Community Development Department
City Planning Division
1685 Main Street – Mail Stop 28
Santa Monica, CA 90401

**RE: Administrative Permit Application / Case No. 22ENT-0073
2601-2645 Lincoln Boulevard**

COMPLIANCE REVIEW COMMENTS/CORRECTIONS

Case Number:	Administrative Approval 22ENT-0073
Location/Zone:	2601-2645 Lincoln Boulevard
Proposed Project:	<p>Tier 1 with State Density Bonus project consisting of a 5-story, 65-foot tall, mixed-use housing project. The project is comprised of 521 residential units (468 market rate + 53 very low-income affordable units), 36,600 square feet of neighborhood serving commercial (retail, restaurant, and grocery store), 850 automobile parking spaces and 822 bicycle parking spaces.</p> <p>State Density Bonus Incentives and Concessions requested with application:</p> <ul style="list-style-type: none"> (1) Increase in maximum building footprint; (2) Relief from AHPP requirement to provide all 2-bedroom affordable units (SMMC Section 9.64.050.E); and (3) Increase in maximum ground floor commercial height to accommodate residential and market loading <p>State Density Bonus Waivers of Development Standards requested with application:</p> <ul style="li

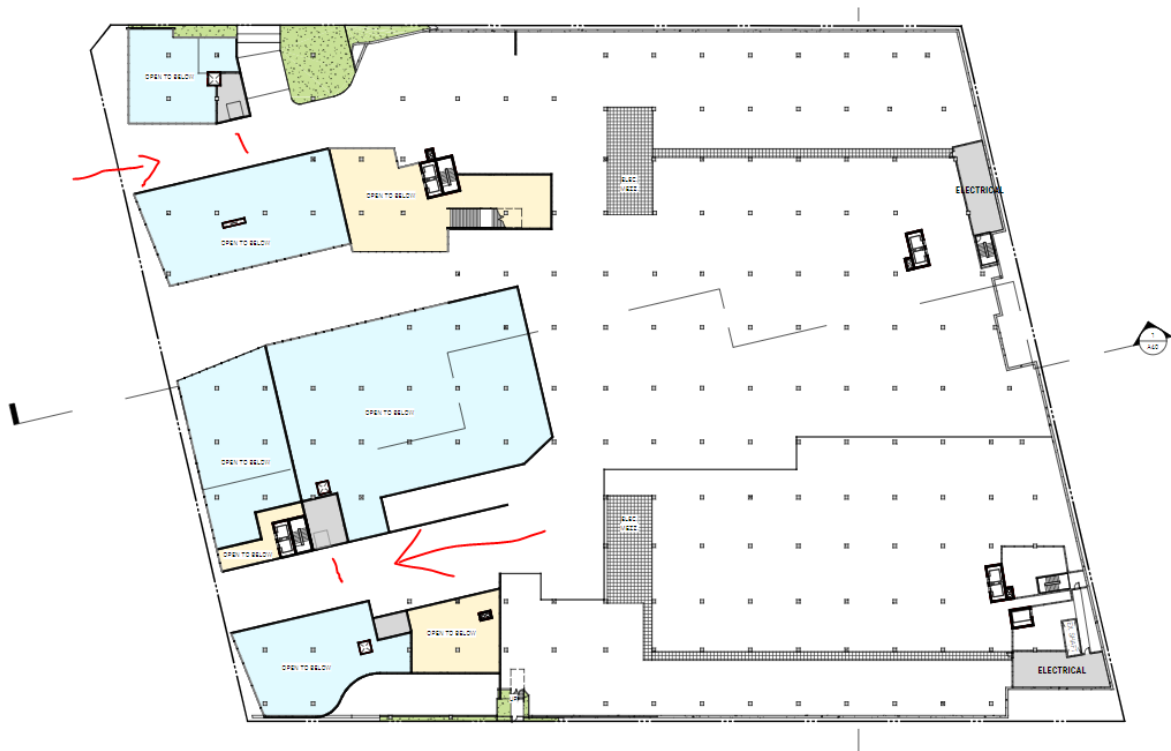
The design proposes separate Commercial and Residential RRR rooms.

The commercial uses are served by 2 RRR Rooms adjacent to the portion of driveways that are open to the sky. Collection can occur in the 25' wide driveways and the trucks can then circulate around through the parking structure which will have a minimum of 14' clearance.

Comment: we need to figure out the drive path for each entrance, I totally forgot to mention it in our meeting, our collection vehicle(s) cannot go against traffic. RRR vehicle needs to stay on the correct side of the drive isle when servicing the location. see below.

Correct

Correct.
